CHAPTER II

COMMENTS ON THE DRAFT MND AND RESPONSES TO COMMENTS

Subject: Potrero to Hunters Point 115 kV Cable Project. (A.03-12-039)

Fig. 2 San Francisco / Peninsula Corridor Transmission System

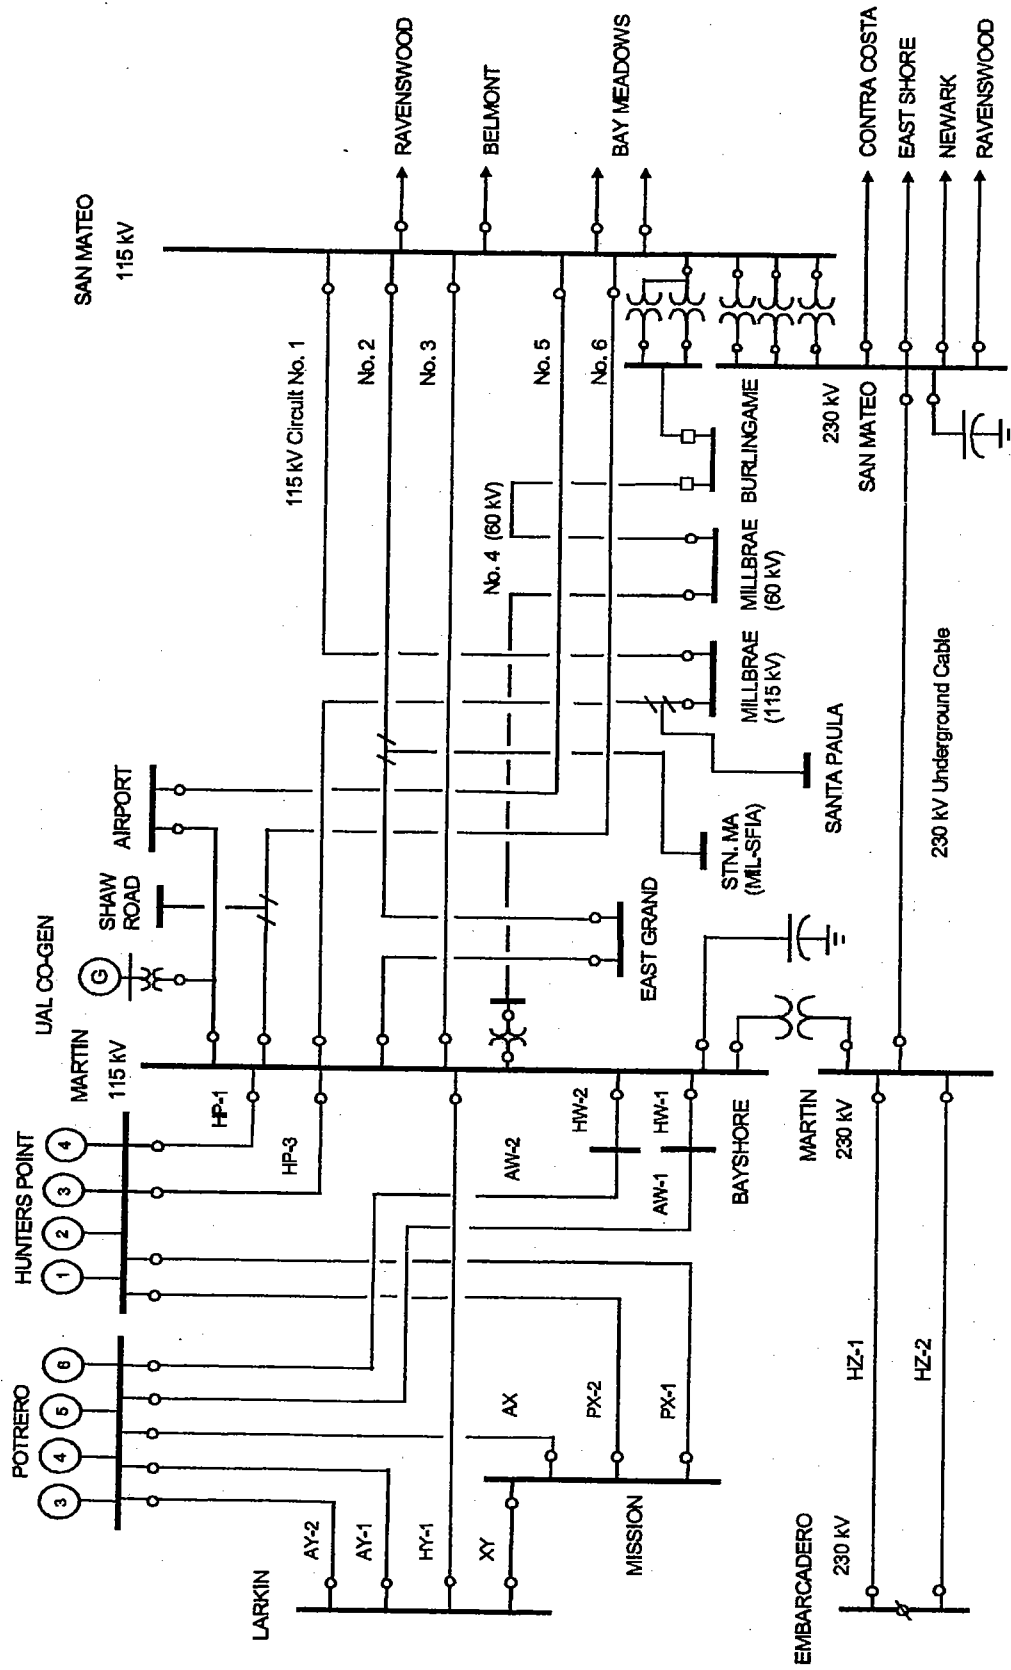
This report does not take into account the fact that PG&E has two 115 kV cable project proposed for connection to the Hunters Point Substation. The projects are a new cable from Potrero Substation and a new cable from the Martin Substation. Computer studies show that these cables are required to handle overload conditions due to a cable failure when the Hunters Point Power Plant is not in operation. The installation of different cables may be a better solution for this overload problem. Like a system of a new cables from the Potrero Substation to the Mission Substation and from the Martin Substation to the Mission Substation and then shutting down the two existing lines from Hunter Point Substation to Mission Substation as these are where the overloads are taking place. It should be noted that the Hunter Point Substation will most likely have a low power distribution requirement if needed at all for power distribution.

D1-1 The comment is regarding the purpose and need of the project. The commenter is concerned that the draft MND does not take into account that PG&E has two 115kV cable projects, a new cable from Potrero Substation and a new cable from the Martin Substation, proposed for connection to the Hunters Point Substation. The comment states that the installation of different cables may be a better solution for this overload problem and notes that the Hunters Point Substation will most likely have a low power distribution if needed at all for power distribution.

Using the CAISO California Grid Planning Criteria, PG&E transmission planners have evaluated various transmission alternatives capable of accomplishing the project objectives. According to this planning effort, constructing a new 115 kV underground cable from Potrero to Hunters Point is the most feasible and cost-effective means of better serving load and improving the reliability of PG&E's electrical system. The San Francisco Stakeholders Study Group, a broad-based, multidisciplinary study group led by the CAISO, has also studied these issues and has independently confirmed the need for the Potrero to Hunters Point 115 kV Cable Project. In December 2000, the CAISO formally approved this project.

The two electric transmission projects considered by PG&E for connection to the Hunters Point Switchyard are the Potrero to Hunters Point 115 kV Cable Project for which PG&E is seeking authorization to construct from the CPUC in application (A.03-12-039) and another project known as the Martin to Hunters Point 115 kV Single Circuit 115 kV Project which is in the planning stages. The Potrero to Hunters Point Project is needed to address more immediate load-serving capability needs in San Francisco and is an element that is needed to allow the closure of the Hunters Point Power Plant. The Martin to Hunters Point Project is needed to address future load-serving capability needs in San Francisco, assuming that the Potrero to Hunters Point Project is already operational. The addition of the Martin to Hunters Point cable increases load-serving capability in San Francisco more than the addition of the two cables (Potrero-Mission and Martin-Mission) mentioned in Mr. Carney's letter. Again, these power flow studies have been reviewed by the San Francisco Stakeholders Study Group, which concurred with the conclusion of the studies.

Building new lines from Potrero Substation to Mission Substation and Martin Substation to Mission Substation and shutting down two existing lines between the Hunters Point Switchyard and Mission Substation as suggested, would not serve as an alternative to PG&E's proposed Potrero to Hunters Point Project. Such a plan would remove needed circuits from the system serving San Francisco since the Hunters Point Switchyard is a vital part of the system.
